SOLICITATION AMENDMENT MODIFICATION DE L'INVITATION

Title - Sujet Closed Circuit Television (CCTV)	
Solicitation No. - N° de l'invitation 21120-141538/A	Amendment No. - N° modif. 002
Client Reference No. - N° de référence du client 21120-14-1991538	Date 2014-04-30
GETS Reference No. - N° de référence de SEAG PW-\$\$HN-313-64788	
File No. - N° de dossier hn313.21120-141538	CCC No./N° CCC - FMS No./N° VME
Solicitation Closes - L'invitation prend fin at - à 02:00 PM on - le 2014-05-07	Time Zone Fuseau horaire Eastern Daylight Saving Time EDT
F.O.B. - F.A.B. Specified Herein - Précisé dans les présentes	
Plant-Usine: <input type="checkbox"/> Destination: <input type="checkbox"/> Other-Autre: <input checked="" type="checkbox"/>	
Address Enquiries to: - Adresser toutes questions à: Kelly, Ruth	Buyer Id - Id de l'acheteur hn313
Telephone No. - N° de téléphone (819) 956-3588 ()	FAX No. - N° de FAX () -
Destination - of Goods, Services, and Construction: Destination - des biens, services et construction:

This amendment is created to address the following:

FIRST FLOOR PLAN

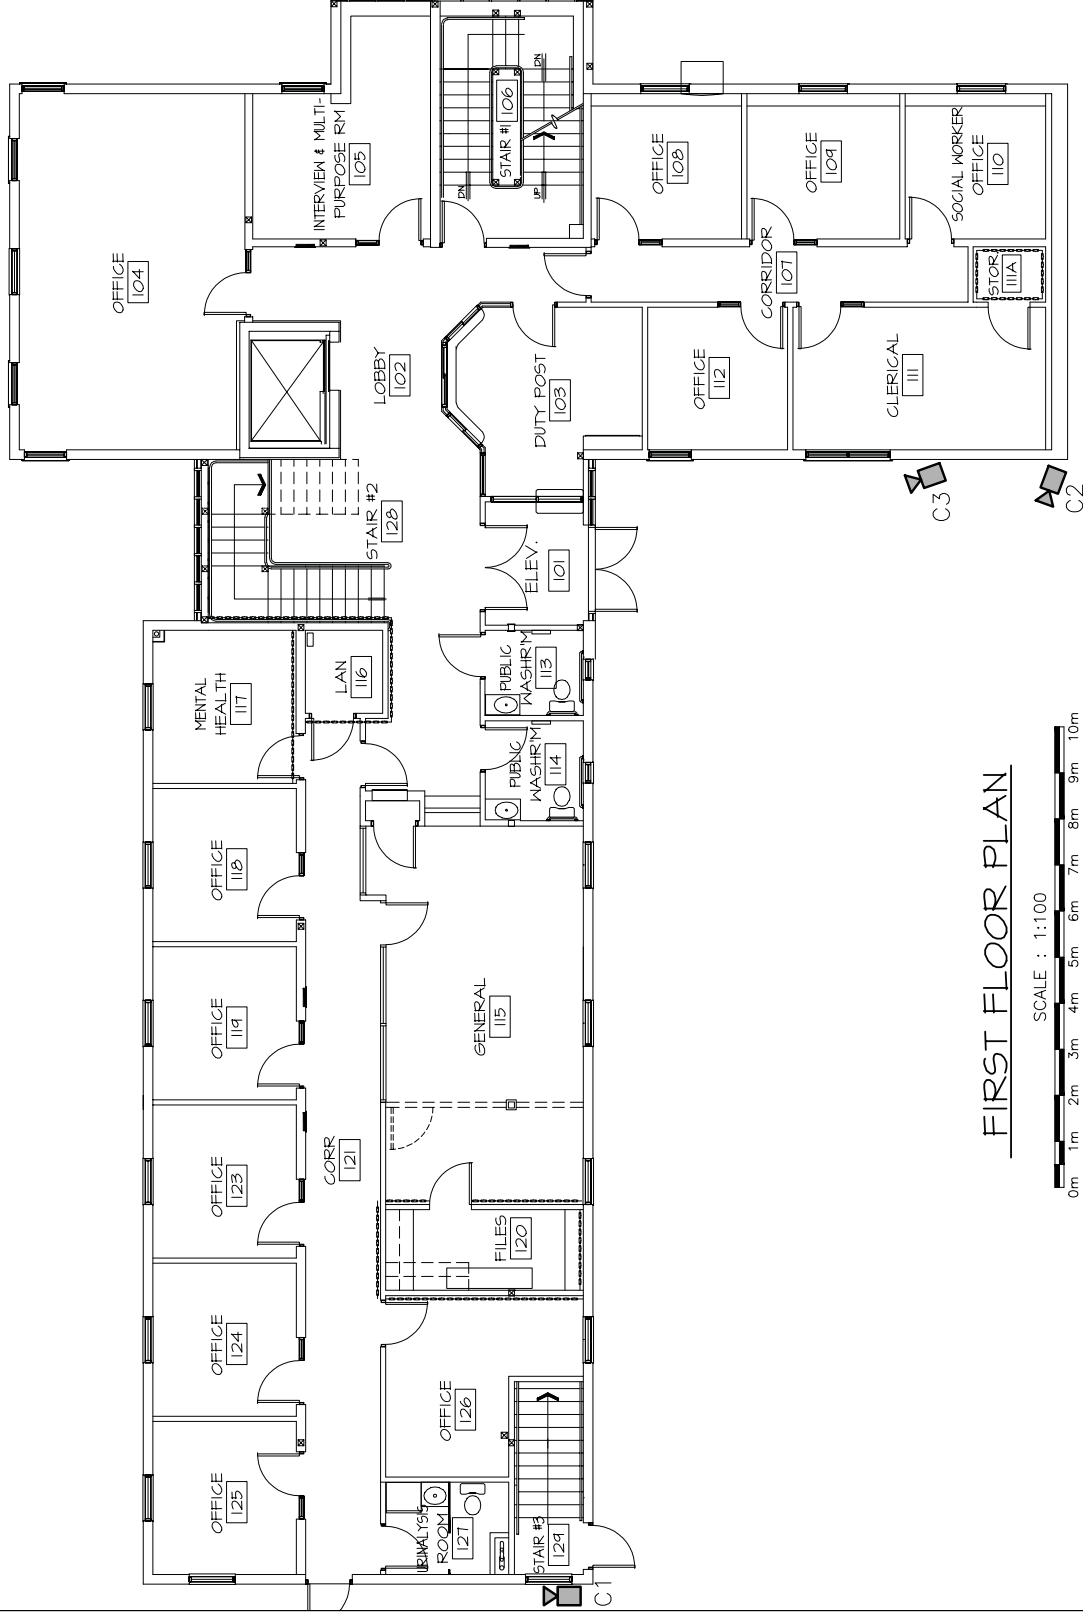
Q16) It was stated during the site visit that the building measurements will be provided in an addendum.

A16) Answer, please refer to attached level 1- Ground floor.pdf drawing for building measurements.
